MURRAY DARLING BASIN MINERAL SANDS OPERATIONS SECTION 75W MODIFICATIONS

DA 345-11-01 Mod 3 (Broken Hill Mineral Separation Plant)
DA 251-09-01 Mod 10 (Ginkgo Mine)
MP 06_0168 Mod 4 (Snapper Mine)

Figure 2: Receiver locations

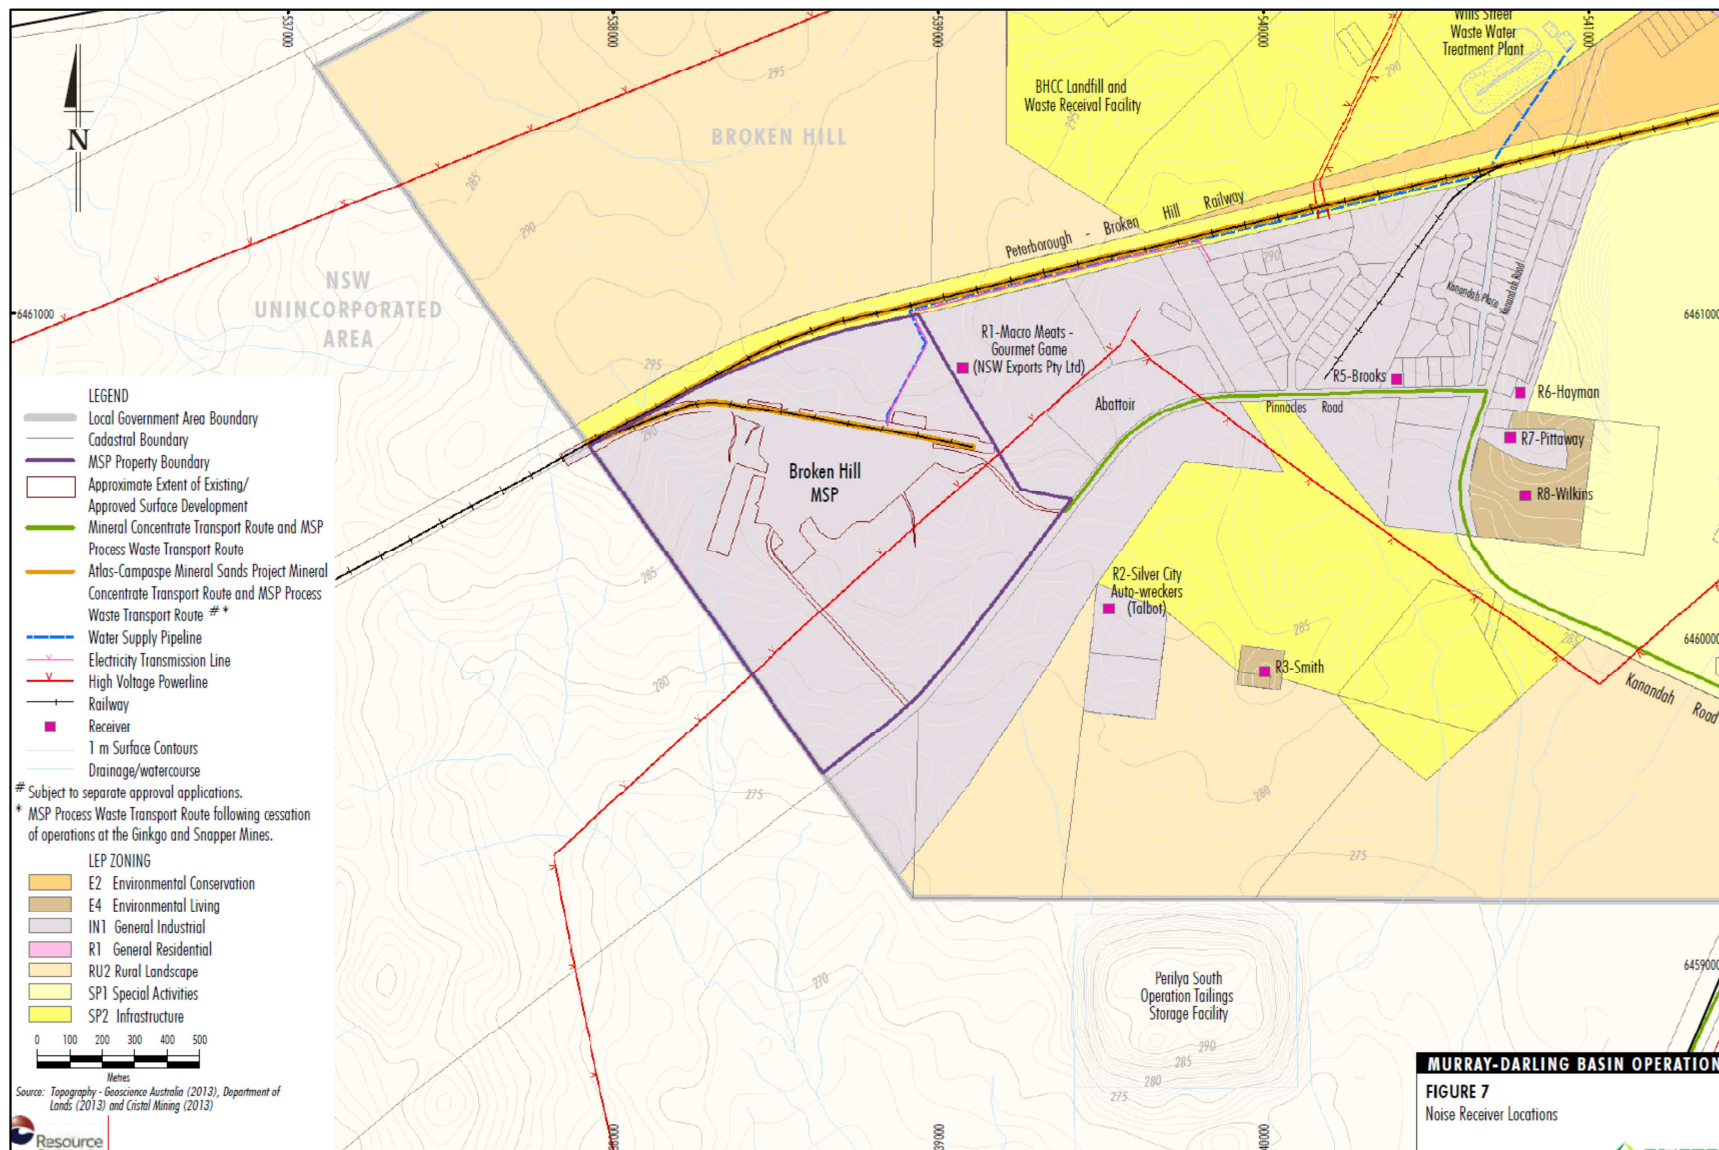
However, under temperature inversion conditions, modelling indicated that there would be a 4 dB(A) exceedance of the PSNL, and a 4 dB(A) exceedance of the sleep disturbance noise criteria of 45dB(A) $L_{Aeq1- minute}$, at one receiver (i.e. R3 – see Figure 2).

- the noise limit at R3 under temperature inversion conditions should be 39dB(A) (instead of 35dB(A));
- compliance monitoring be undertaken at R3 within 12 months to ensure Cristal is complying with this limit; and
- that the landowner of R3 should be entitled to noise mitigation measures such as double glazed windows, insulation and air conditioning.

However, Cristal argued that if R3 was entitled to additional noise mitigation, the higher noise limit of 39 dB(A) should be applied at all times, rather than only during adverse weather conditions. Cristal argued that applying the lower noise limit of 35 dB(A) outside adverse weather conditions would complicate compliance and would not be consistent with contemporary regulatory practice.

The Department acknowledges Cristal's objections, but has adopted EPA's recommended approach in the modified conditions. Applying the higher limit (as suggested by Cristal) would not support the intent of the INP, which is to achieve appropriate amenity noise levels by avoiding 'noise creep' from other developments that may be established in the same area. Furthermore, because temperature inversions are a feature of the area (i.e. they occur more than 30% of the time). The Department believes it is reasonable, and consistent with the INP, to have a specific noise limit that only applies when these conditions occur.

Overall, the Department is satisfied that noise impacts associated with increased processing at the MSP can be appropriately managed, provided the recommended management measures are implemented. The Department has incorporated these measures into the modified conditions, including a requirement for Cristal to notify the owner of R3 that he/she is entitled to additional noise mitigation measures.
